# **Faversham Society Archaeological Research Group with Friends of Oare Gunpowder Works**

## **Report for the geophysical survey and Map Regression prior to creation of a Habitat Pond within Oare Gunpowder Works Country Park (Revision A)**

**Date of Report (Rev A): 10<sup>th</sup> May 2020**

The report has been revised to address several comments made by Historic England. These comments are addressed below:

Figure 3 Resistivity Survey: Measured Values (left) and Plotted Results (Right)

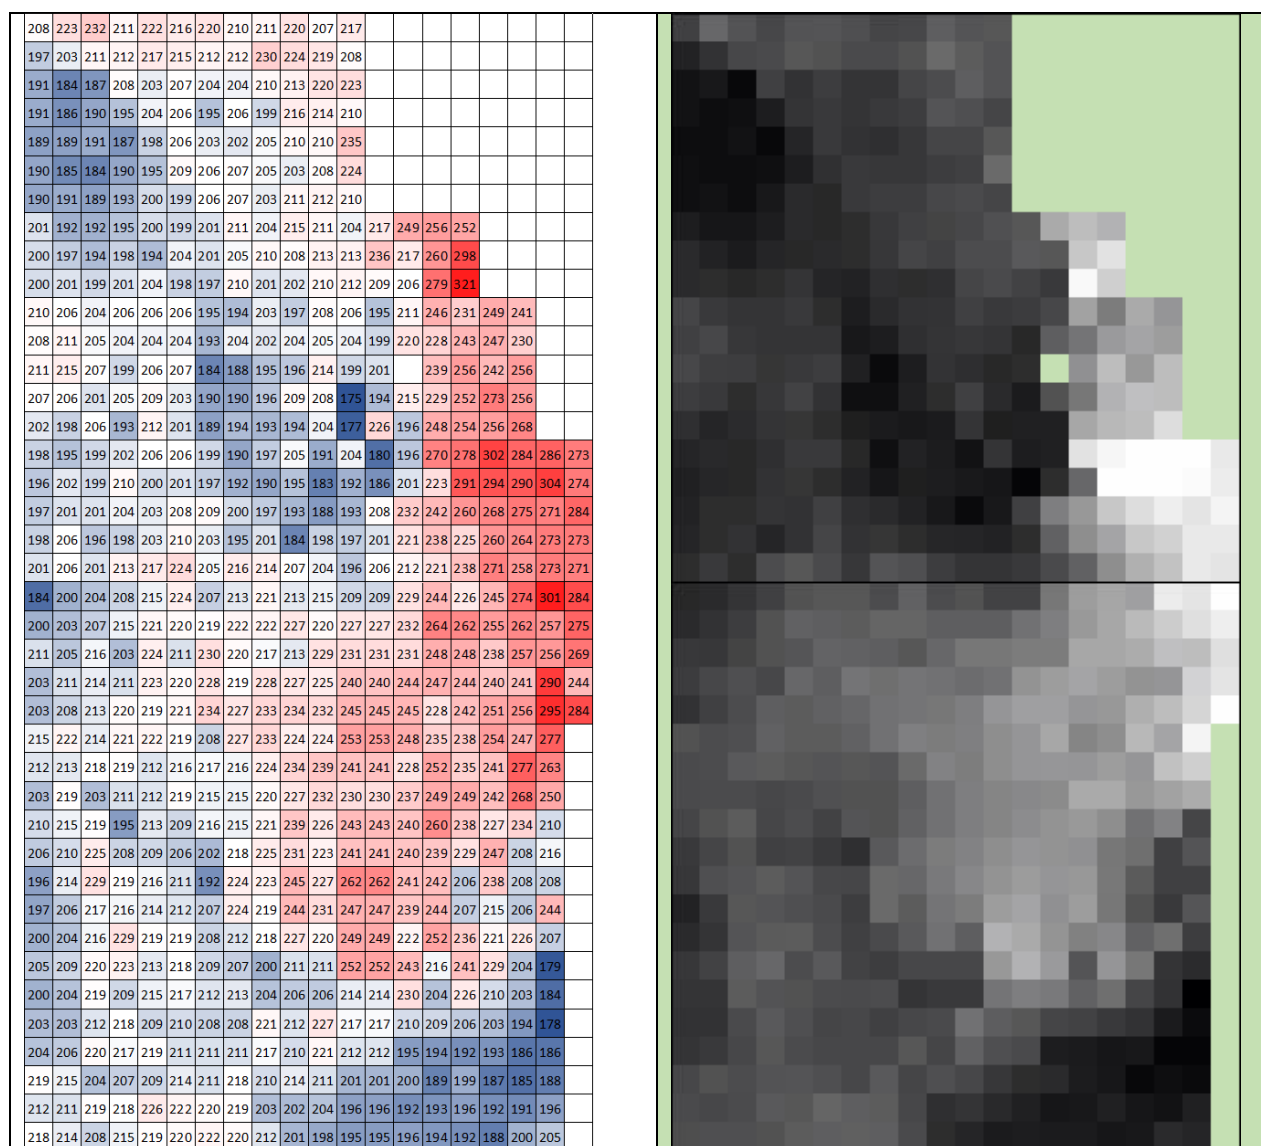
### 2) **Processing of resistivity data causing distortion of results and reversed colours** – The data has been replotted with high resistance as white. The data processed in Terra Surveyor is subject to de-spiking with a window of 3 and threshold of 1 and clipping the data to 3 standard deviations. The survey result overlay has been realigned with the new baseline measurements.

The table of results to the left is the raw measured values from the survey, blank cells are points where no measurement was taken due to obstruction by trees. The cells are coloured with dark blue the lowest (wettest) and red the highest (driest) measurement. The image on the right has been created by processing the data on the left through Terra Surveyor by clipping the data to 3 standard deviations and de-spiking with a window of 3 and threshold of 1. Green areas are points where no measurement was made, it was not possible to extend the survey due to dense undergrowth. Dark is low resistance (wet).

*Figure 11 - Final Composite Plan*

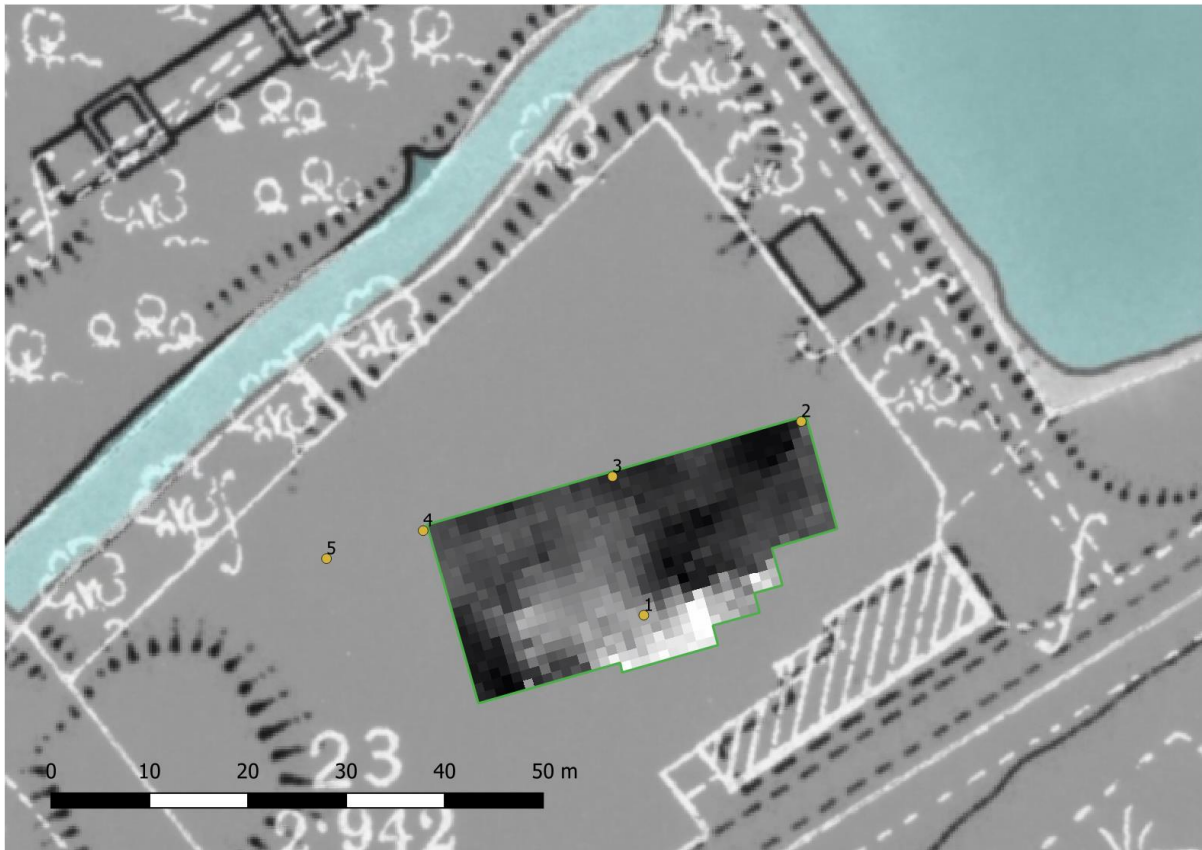
### 1) **Accuracy of the survey baseline -**

- a. The baseline has been re-established using the original reference points and then measured using a survey grade GNSS Receiver to an accuracy of better than 10cm. There may be an added 20cm or so error in re-establishing the baseline. However, compared to the 1 metre survey grid resolution and the uncertainties in aligning the historic maps this is small.
- b. The 1897 Ordnance Survey 2500:1 map is included because this clearly shows the building in question.
- c. The maps have all been geo-located so that they reference back to current Ordnance Survey Data.
- d. We no longer use Google Earth data since it seems to be misaligned by a few metres when compared with the Ordnance Survey data, the Lidar Data and the survey grade GNSS Receiver.
- e. Models based on Lidar DSM data as well as the DTM data are included.

To accurately align the resistivity data, the baseline was re-established from the same fixed reference points used for the original survey. The corners of the northerly edge of the survey grid were measured using a survey grade GNSS receiver. There are 5 points shown on the composite.
